SUBJECT: Addendum No. 1
City of Lookout Mountain, GA
Chickamauga Trail Pump Station Improvements

ADDENDUM NO. 1

CHICKAMAUGA TRAIL PUMP STATION IMPROVEMENTS

CITY OF LOOKOUT MOUNTAIN, GEORGIA
GEFA LOAN NUMBER: GF2024017
CTI PROJECT NO. G24017-01

JOB NO. G24017-01
ISSUE DATE 04/01/2025
DRAWING NO. C-002.1

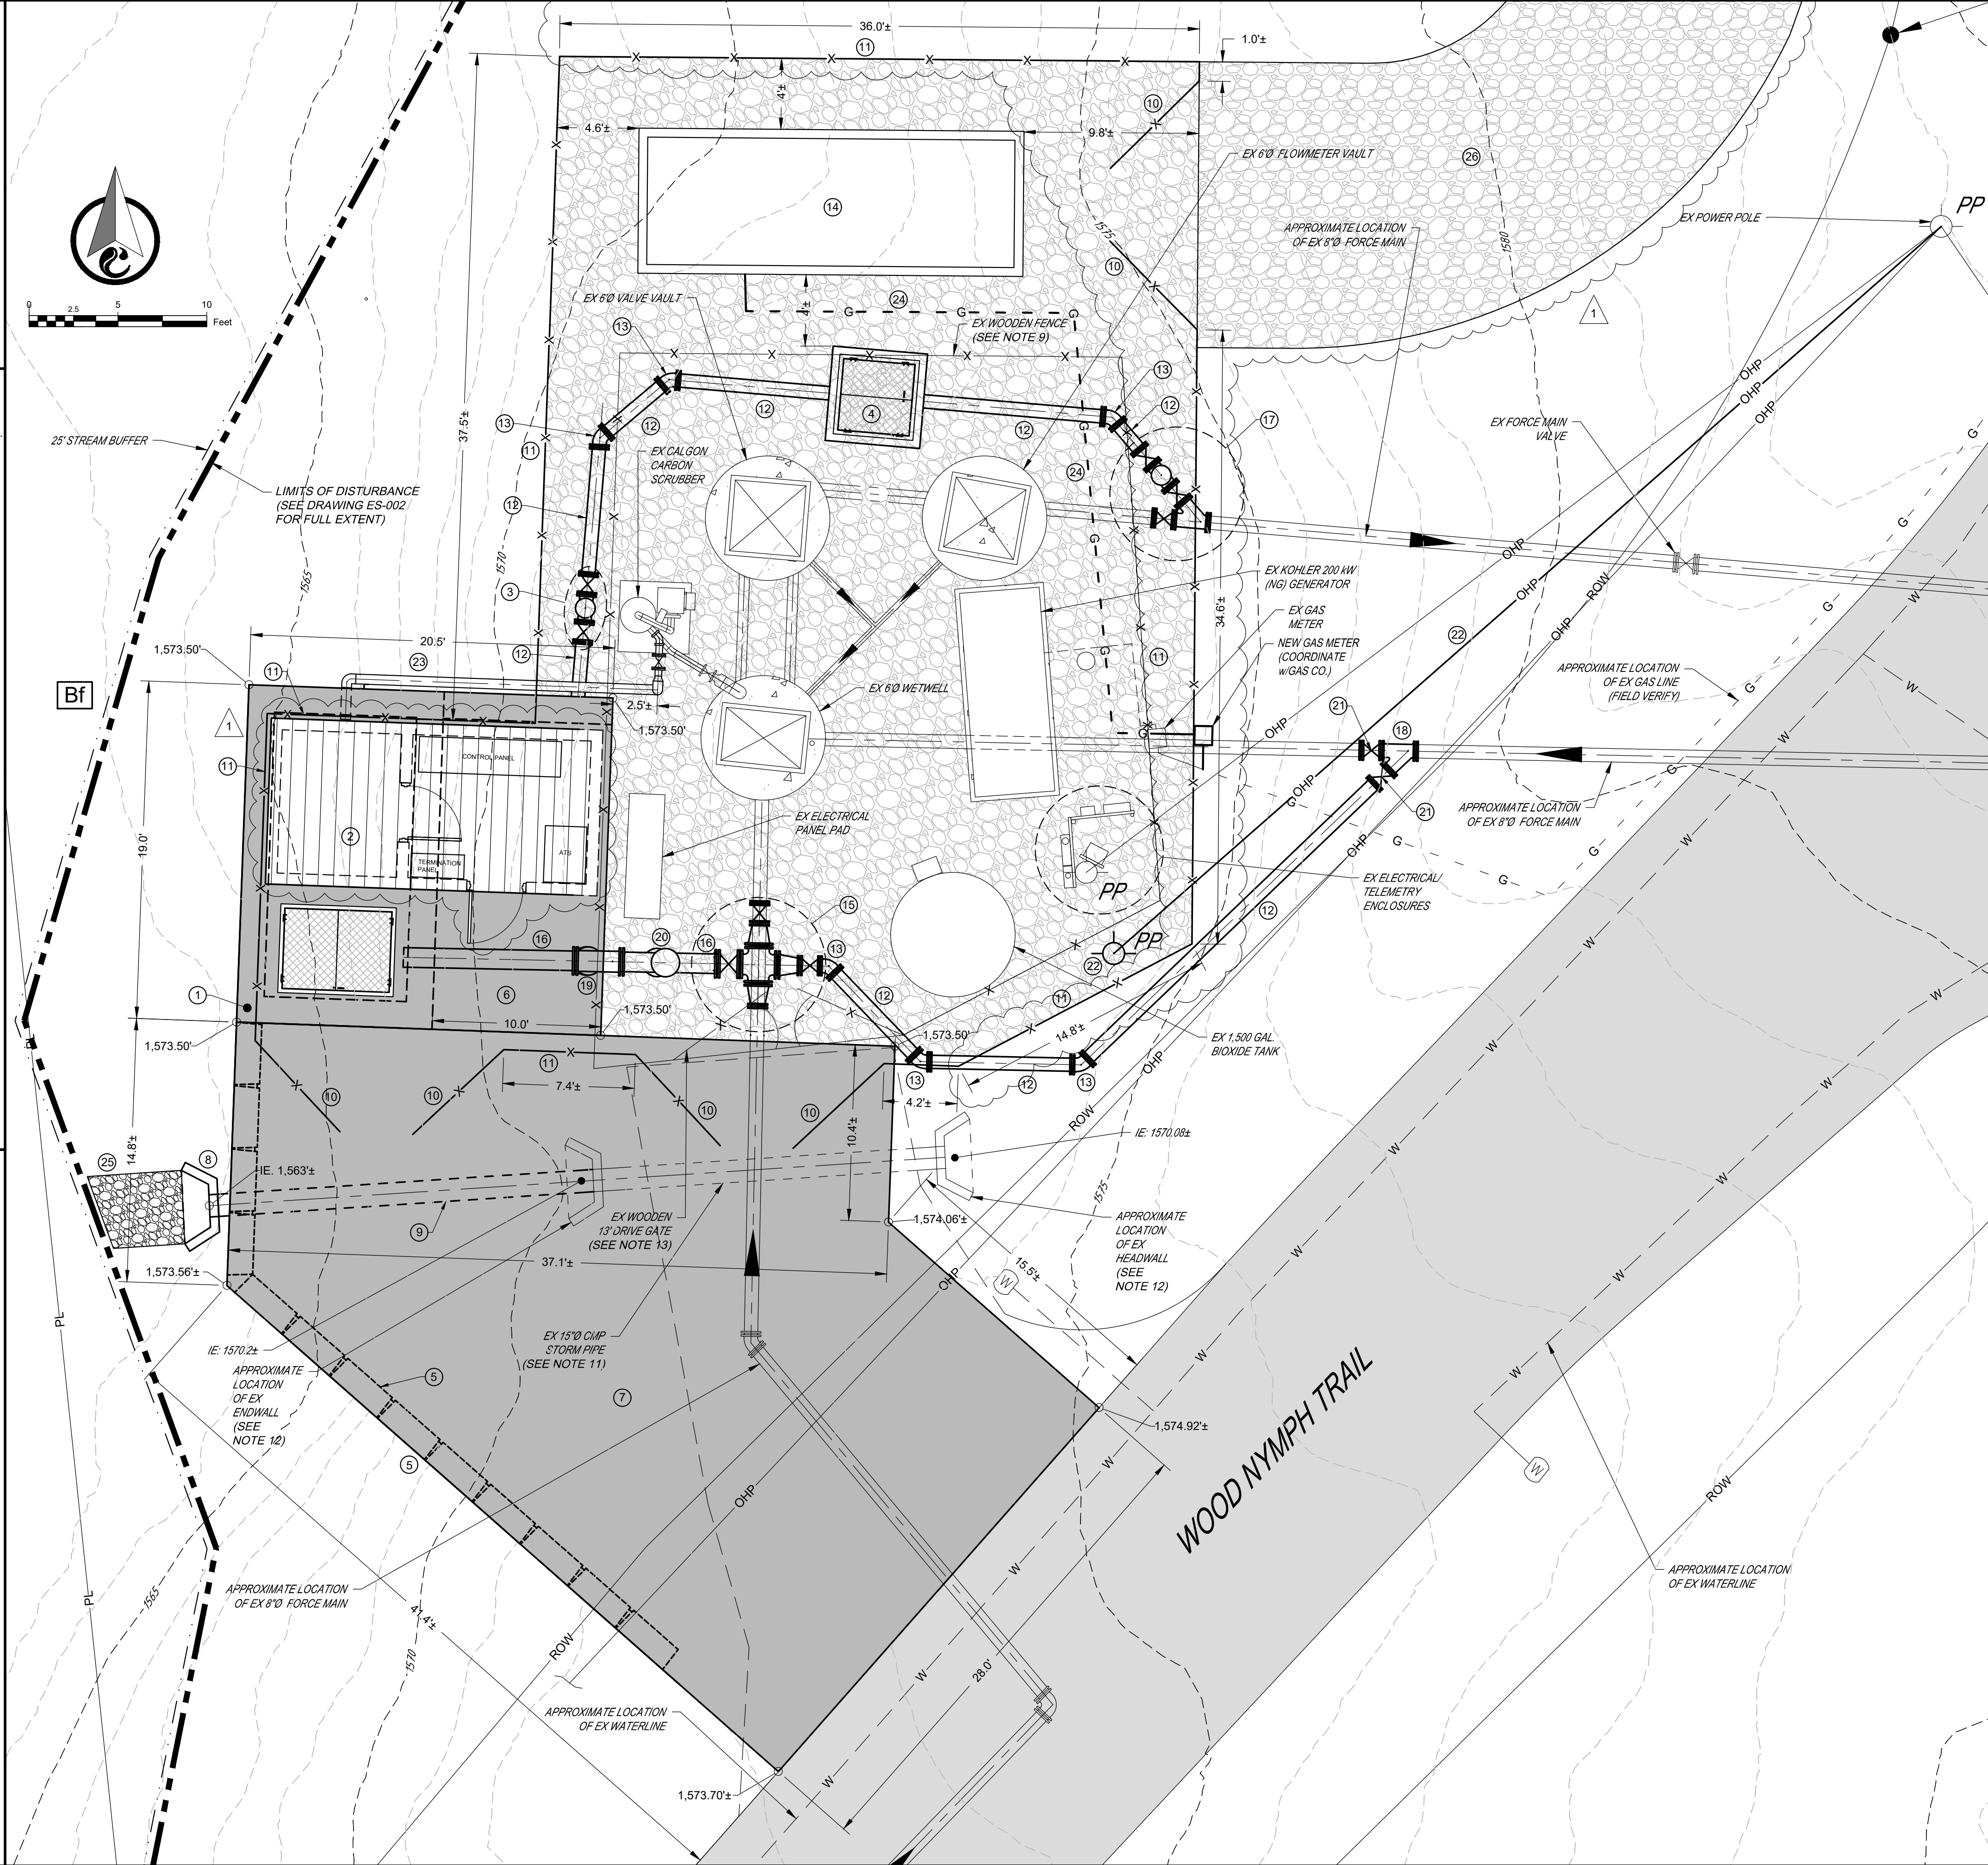
DESIGN		REVISIONS		BY		DATE	
NO.	DESCRIPTIONS	DDT	DDT	DDT	DDT	DDT	DDT
1	LENGTHENED MASONRY BUILDING, REVISED FENCE LAYOUT, & ADDED ACCESS DRIVE					08/25

M-001.1

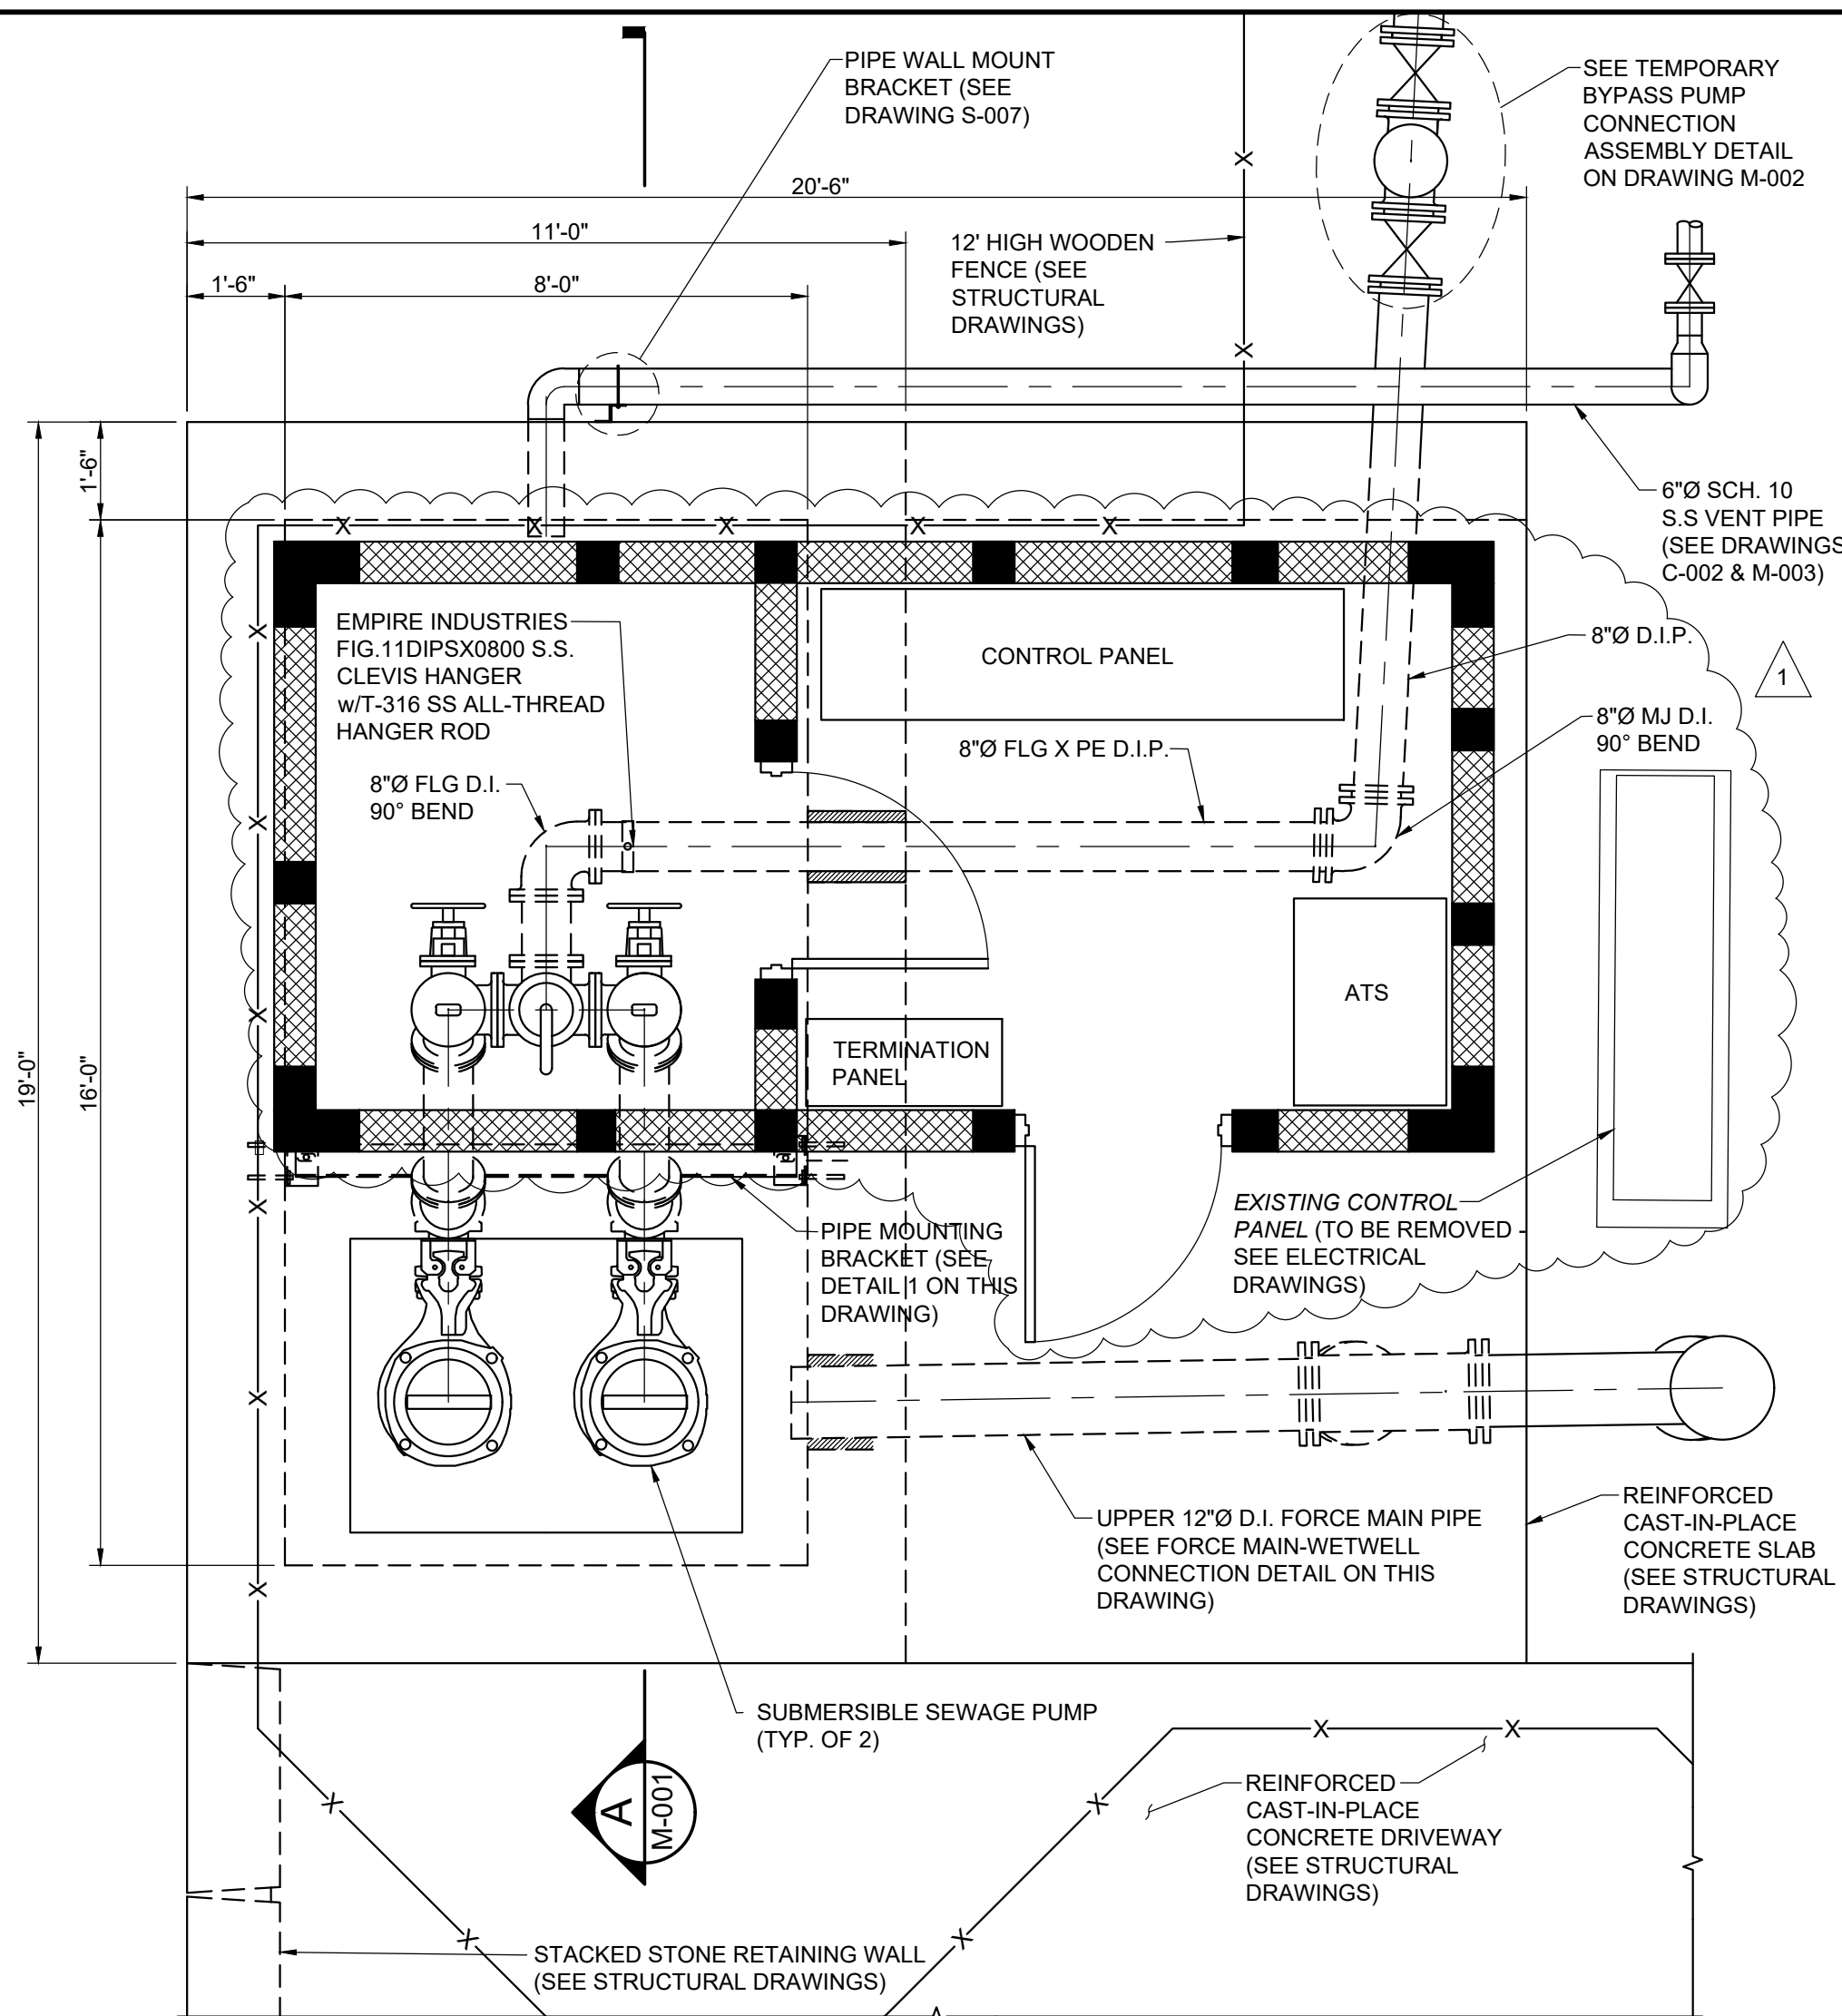
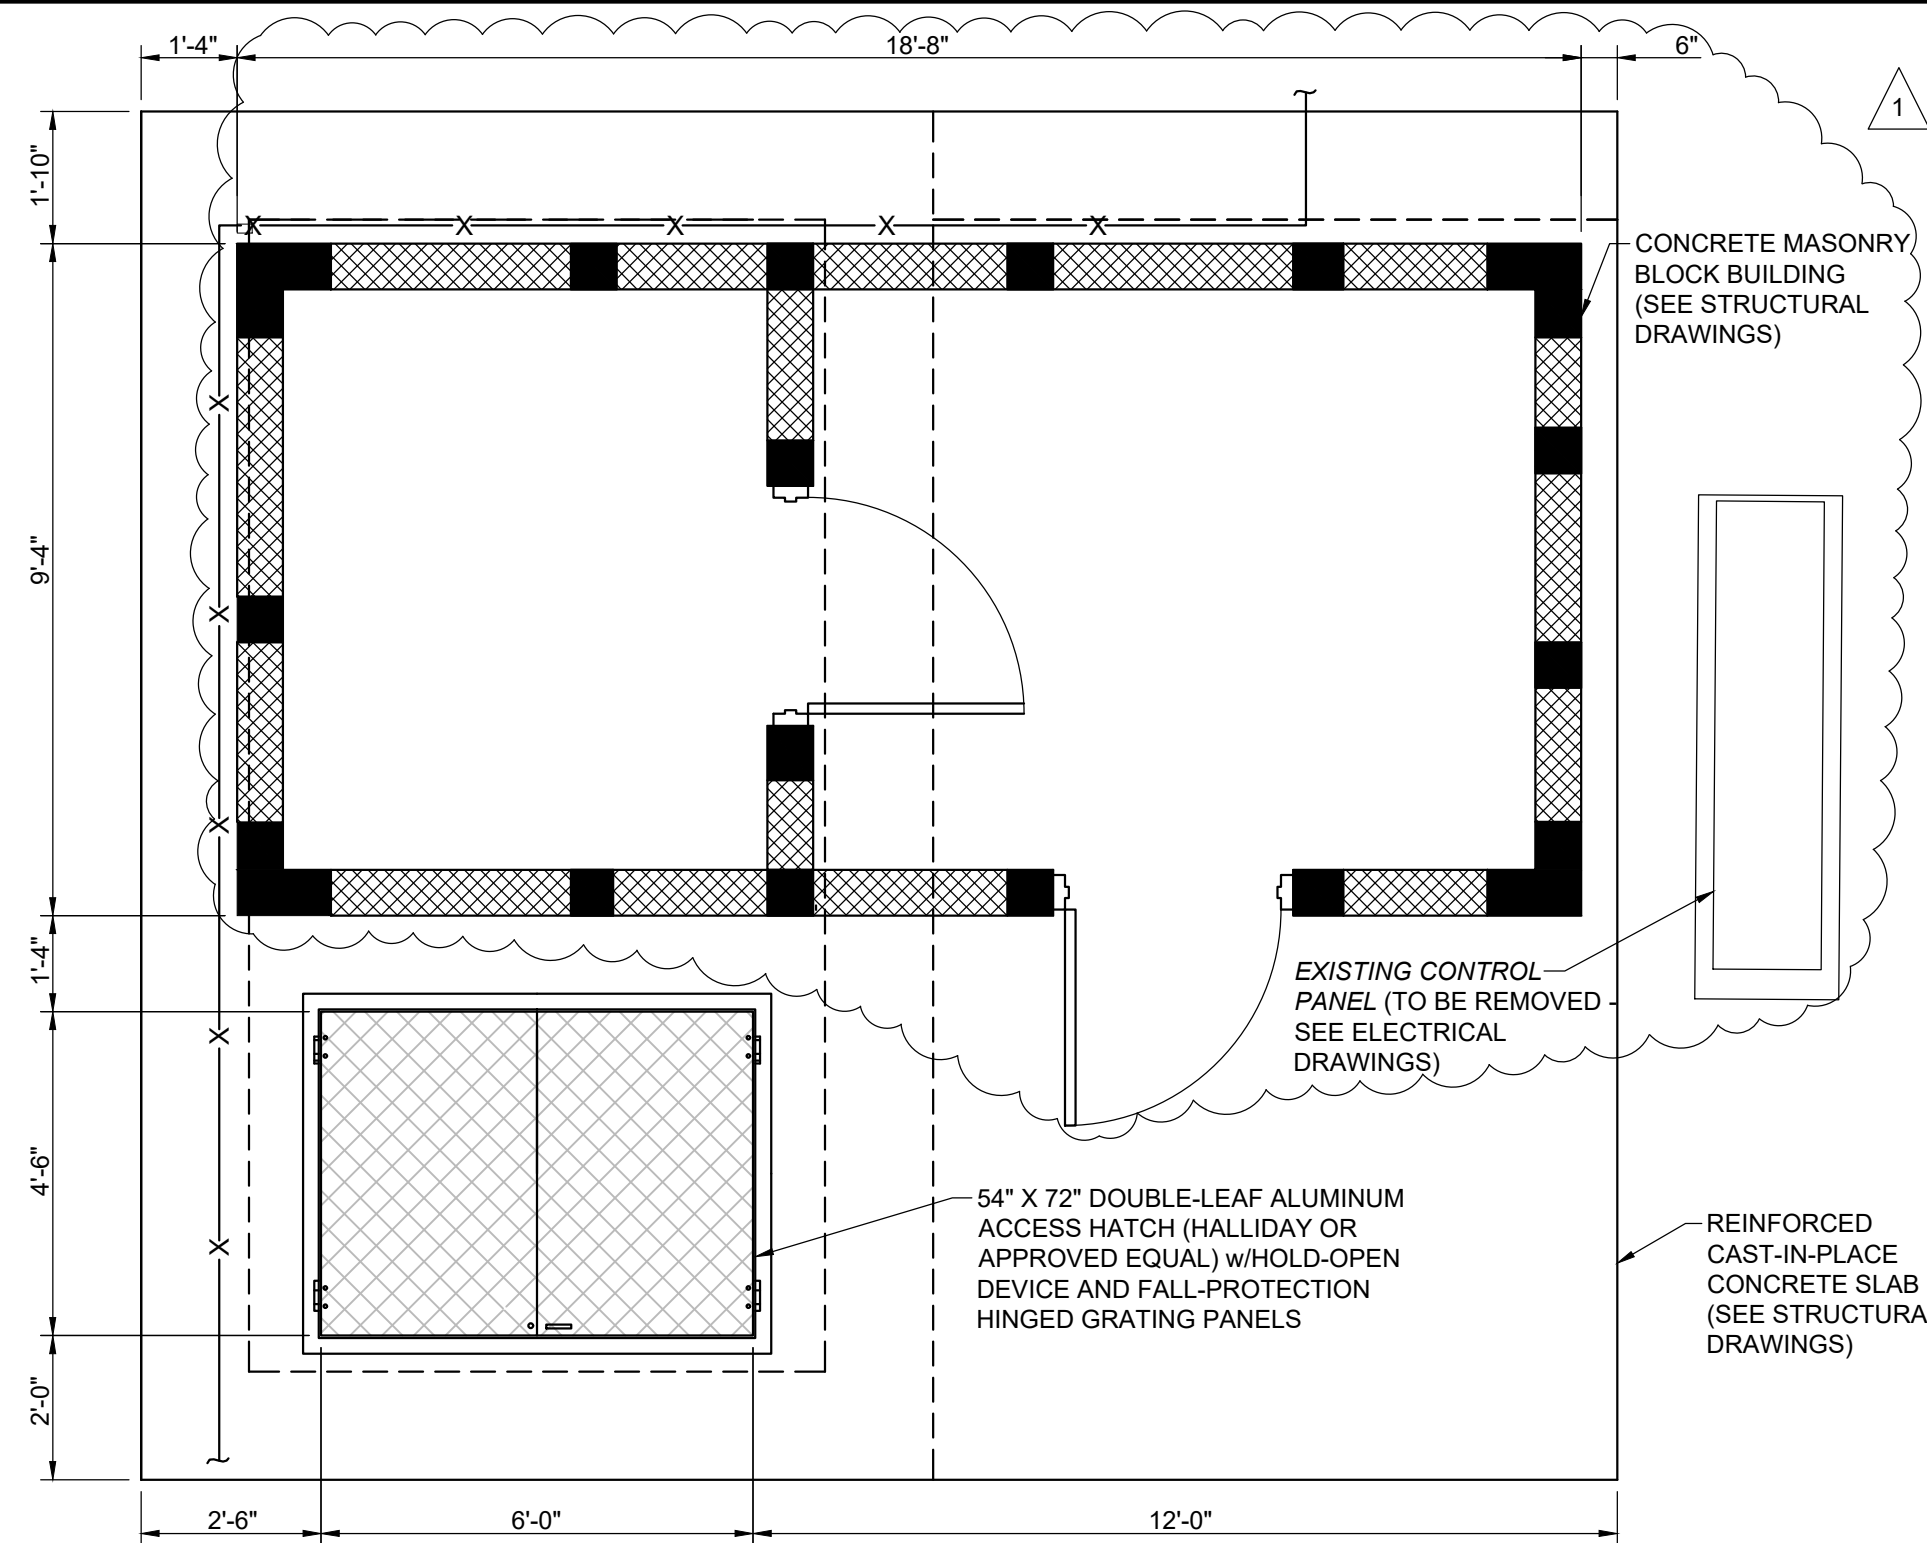
REVISIONS				
NO.	DESCRIPTIONS	DATE	BY	APPD
1	LENGTHENED MASONRY BUILDING	08/25	DDT	DDT
